# Culture, Parks & Recreation Department (CPRD)

Comprehensive Master Plan-Appendix C

Design Recommendations and Opinions of Probable Cost (Rough Orders of Magnitude)

BITTERSWEET 4A - Northern bank of pond lacking programmed water access (view to southwest).

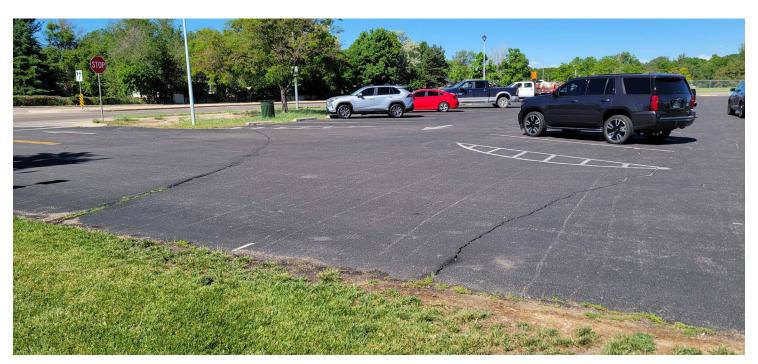
CPRD Team Input	Design Team Recommendations
None.	GENERAL  1 - Include playground in the system life-cycle replacement program (medium priority, replace in 5-10 years) to allow City to prioritize enhancements and budget for equipment over time.  [PHOTOS 1A, 1B, 1C, 1D]
	IMPROVEMENTS  1 - Redesign southern parking lot and basketball court area to create a better sense of arrival to park.  [PHOTO 2]
	2 - Add shaded seating and perimeter fencing at the basketball courts to improve overall visitor experience. [PHOTO 3]
	3 - Provide more shade at playgrounds to reduce sun exposure to children and improve overall visitor experience. [PHOTOS 1A, 1B, 1C, 1D]
	4 - Provide programmed water access (i.e., piers) to improve overall user experience. [PHOTOS 4A, 4B]
	MAINTENANCE 1 - Repave parking lots. [PHOTOS 5A, 5B]
	2 - Repair cracked sidewalks. [PHOTO 6]
	3 - Correct ponding at playground. [PHOTO 7]
	4 - Reestablish turf in the northern "Grasspave" access drive. [PHOTO 8]

SHERWOOD 5 - Eastern parking area near pickleball courts in need of re-design.

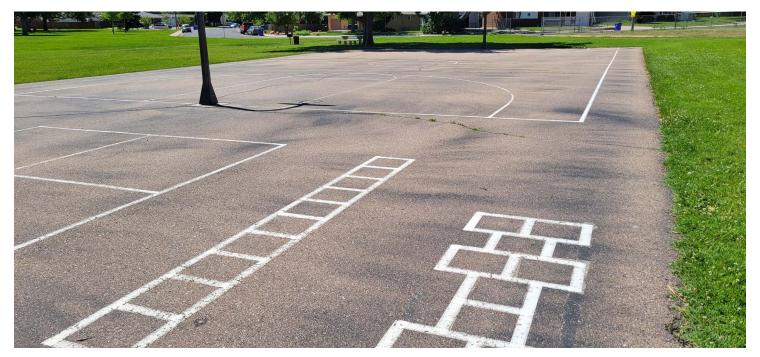
CPRD Team Input	Design Team Recommendations
None.	GENERAL  1 - Include playground in the system life-cycle replacement program (medium priority, 5-10 years) to allow City to prioritize enhancements and budget for equipment over time.  [PHOTOS 1A, 1B, 1C]
	IMPROVEMENTS  1 - Replace asphalt basketball court pavement with post-tension concrete for more durability (scheduled for 2025).  [PHOTO 7]
	2 - Incorporate general diamond field improvements (dugouts, bleachers) to improve overall visitor experience. [PHOTO 3]
	3 - Remove excess pavement by playground. [PHOTO 2]
	4 - Provide more shade at the playground to reduce sun exposure to children and improve overall visitor experience. [PHOTOS 1A, 1B, 1C]
	5 - Consider redesigning the eastern parking area to provide additional parking (need exceeds current capacity and visitors are parking along alleyway). [PHOTOS 5]
	6 - Provide shaded seating at pickleball courts to improve overall visitor experience. [PHOTO 9]

SHERWOOD 7 - Close-up of existing asphalt surface.

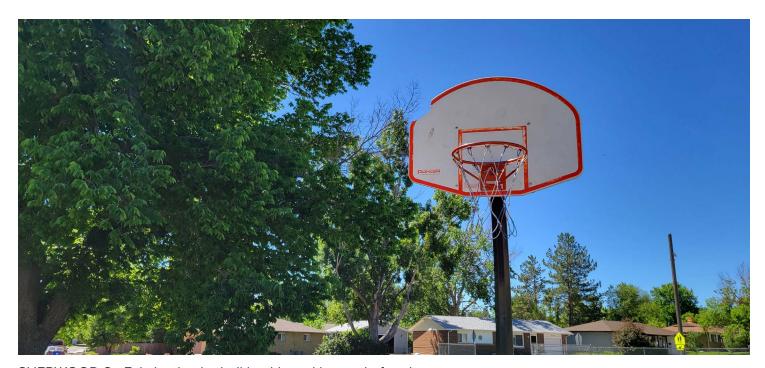
7 - Provide shaded seating at basketball court to improve overall visitor experience. [PHOTO 7]
	MAINTENANCE 1 - Replace backstop fence fabric. [PHOTO 4]
	2 - Replace basketball backboards/goals (scheduled for 2025). [PHOTO 8]
	3 - Repair or replace wooden fence. [PHOTO 6]
	4 - Correct ponding issues along pathways. [PHOTO 10]

UCCC 1 - Main entry signage in need of improvements to differentiate building from adjoining Recreation Center.

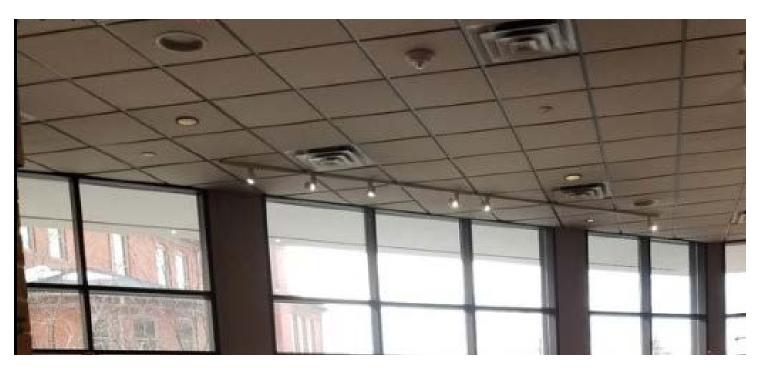
CPRD Team Input	Design Team Recommendations
To create more recognition, staff expressed interested in updating and redesigning the UCCC and renaming the facility. Consideration is also being given to redesigning the courtyard for improved utilization and reconfiguring outdoor spaces to create a stronger connection with Lincoln Park and the Farmers' Market. UCCC theater seats need to be reupholstered or redesigned.  Please refer to Facility Assessment accompanying this report.	GENERAL  1 - Internally assess facility vision, program, operations, facility conditions, opportunities/limitations, etc  2 - Engage planning/design professional to facilitate a re-visioning and master re-design effort that focuses on establishing an updated identity/brand and wayfinding needs.  IMPROVEMENTS  1 - Renovate courtyard and its connections to adjacent spaces.  2 - Upgrade overall finishes, particularly in theater greenrooms.  3 - Redesign lobby layout and finishes to provide a fresh and more updated appearance.  4 - Implement wayfinding redesign to differentiate the building from the Recreation Center as well as improve ability to locate entrances and navigate the building.  [PHOTO 1]  5 - Upgrade seating.  [PHOTO 2]  MAINTENANCE  1 - Update finishes throughout the building.  2 - Upgrade stage elevator and flooring.  3 - Replace water-damaged ceiling in the lobby.  [PHOTO 3]

ICE HAUS 1 - Existing viewing area in need of additional seating.

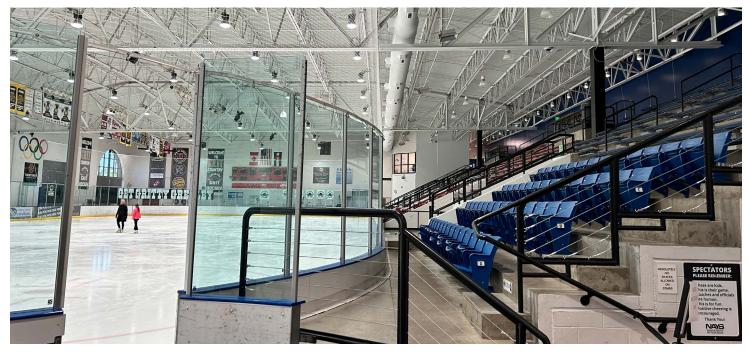
CPRD Team Input	Design Team Recommendations
Internally assess and consider a master redesign effort focused on expanding the facility to accommodate demand, upgrade the mechanical system, and address need for additional storage.	GENERAL  1 - Internally assess facility vision, program, operations, facility conditions, opportunities/limitations, etc.  2 - Engage planning/design professional to facilitate a re-visioning and master re-design effort that focuses on expanding the facility.  IMPROVEMENTS  1 - Replace mechanical equipment (current equipment is based on the original, larger design that included two sheets of ice; rather than be more efficient, this large systems causes excessive wear and tear).  2 - Provide additional ice sheet to accommodate demand (consider expansion into the adjacent parking lot that is underutilized).  3 - Provide additional seating.  [PHOTO 1]  4 - Provide additional office space at upper-level.  [PHOTO 2]  5 - Provide new ice training area.  [PHOTO 3]  MAINTENANCE  None.
